# Professional Audio Service Bulletin

BULLETIN NO. 16

**SUBJECT:** Modification to Sync Amplifier Circuitry

**APPLICABLE TO:** All M-79, 8, 16 and 24 Track Recorders

FIGURE 1

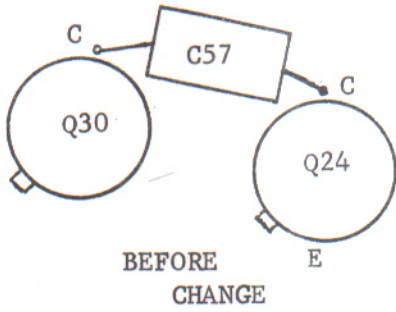
1. Remove Capacitor C-57 which is connected between the collectors of Q-30 and Q-24 (see figure 1).
2. Drill one hole using a .030/.035 inches, drill adjacent to the emitter connection of Q-24 (see figure 2).

FIGURE 2

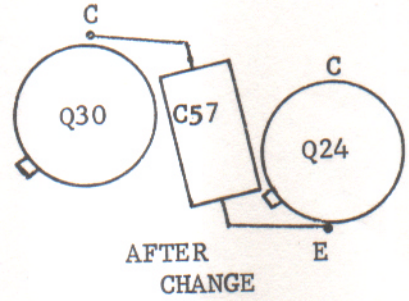
3. Install the new 560pf capacitor, designated C-57, between the collector of Q-30 and the emitter of Q-24 (see figure 2). Insert capacitor lead through new hole, then bend the lead to the emitter trace of Q-24, then solder.
4. Check Recorder alignment and adjust if necessary.
5. Change Instruction Manual schematics and parts list to reflect the new location of C-57 as indicated by figure 3.

FIGURE 1

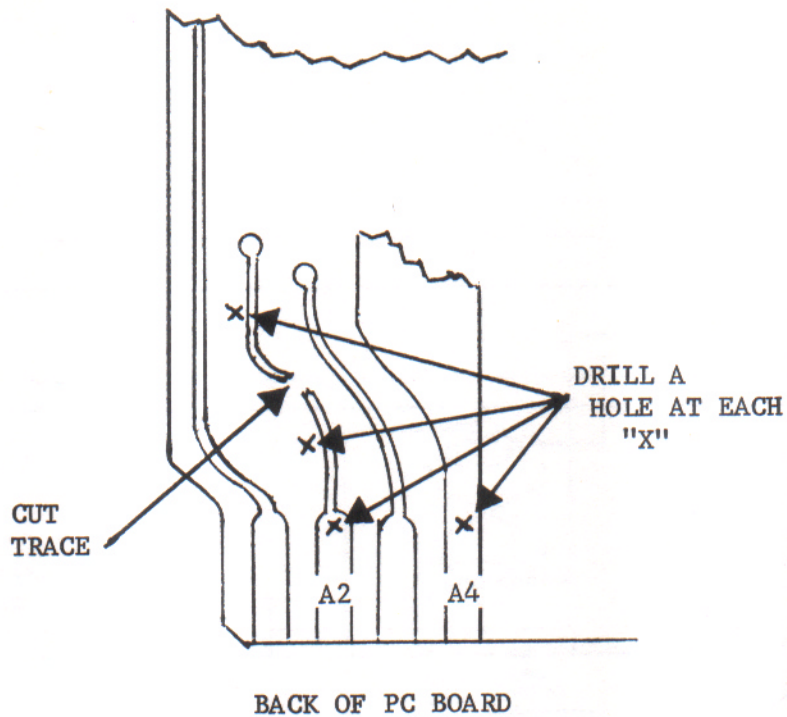
1. Drill four holes .041/.046 inches in diameter at points indicated on figure 1.

2. Cut the printed circuit trace as indicated on figure 1.
3. Install the capacitor, designated C-62 in the holes drilled in the finger contacts (see figure 2). Insure the leads lie flat against the board to prevent shorts to the board brace.
4. Install the resistor, designated R139, as indicated in figure 2. Bend the leads to make contact with the trace on the back of the board and solder. R-139 must be bent as shown to prevent accidental short circuits and to permit the board to be installed in the Recorder.
5. Change Instruction Manual schematics (see figure 3) and parts list to reflect C-62 and R-139.

Figure 2

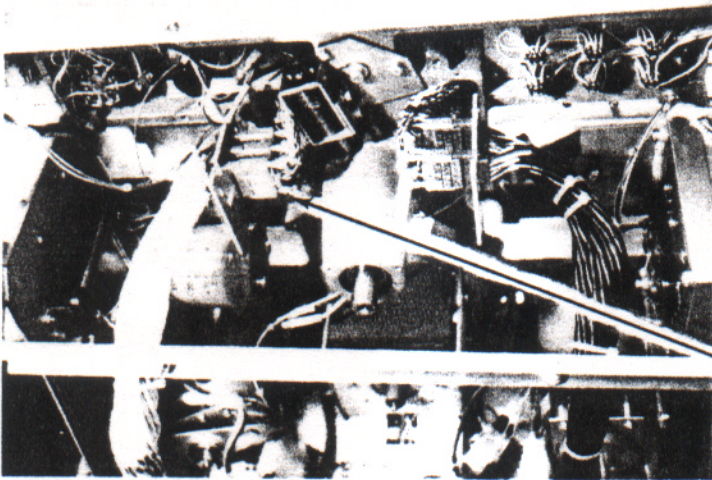
- b. Install new bracket assembly onto transport. (Figure 1)
  - c. Reconnect head connector(s). (Figure 2)
4. Repeat steps 2 and 3 above for bracket on record side.

Arrow shows head  
connectors reconnected

FIGURE 2

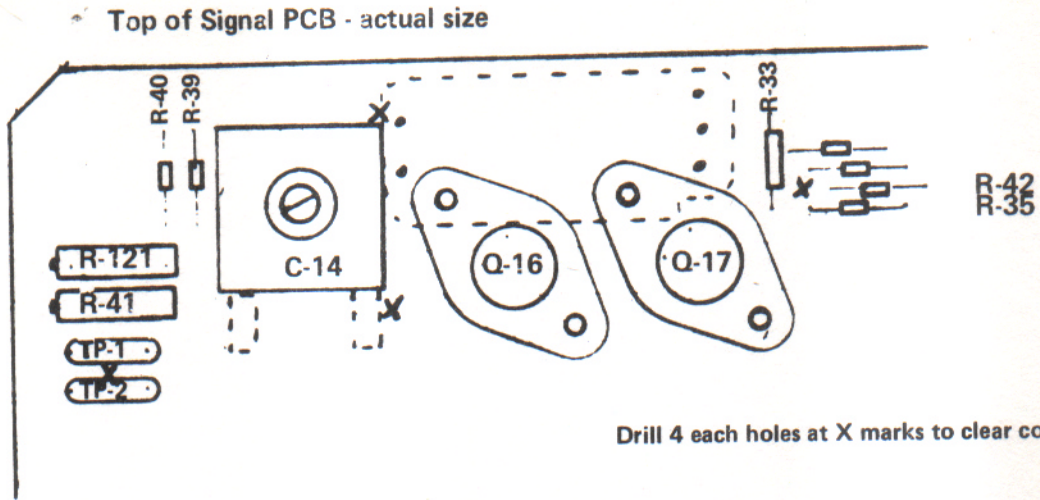
7. Locate same trace as in Step 5 and drill a hole into this trace between C-14 and Q-16 (see figure 1).
8. Mount relay K-A on a piece of perf board and mount the perf board to the mounting screws of Q-16 and Q-17 using two 6-32 nuts (see figures 1 and 2).

FIGURE 3

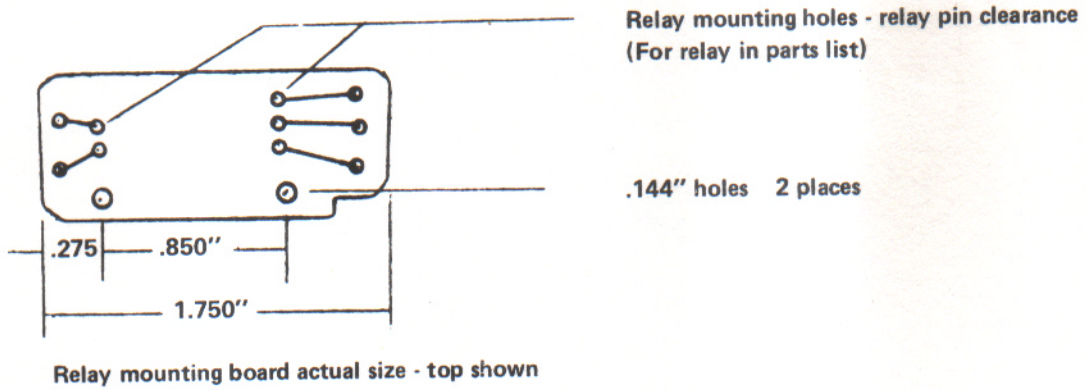
New Circuit Configuration
